適航指令發布單
Airworthiness Directive Issuance Form

No. TCD-8201C-2-2022

Airworthiness Directive

1. Applies to: Kawasaki BK117 series helicopters equipped with a Goodrich rescue hoist assembly having a Part Number (P/N) as listed in Table 2.1 of this AD.

Figure 1

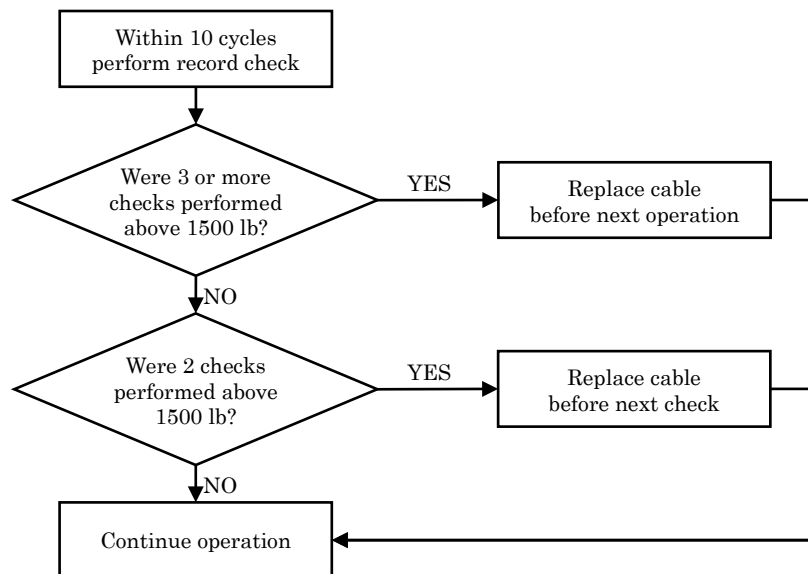
2.1 Within 10 hoist operating cycles from June 17, 2016 (the effective date of AD No. TCD-8201C-2016), accomplish a records check to determine whether, during any previous hoist load check/test, a cable was load-tested (average of 5 pulls) at 1500 lb [680 kg] or more. If any cable is identified to have exceeded this limit during two or more hoist load checks/tests, replace the affected cable with a serviceable cable within the time interval shown in paragraph 2.1.1 or 2.1.2 of this AD. For replacement of a cable, see Figure 1 of this AD.
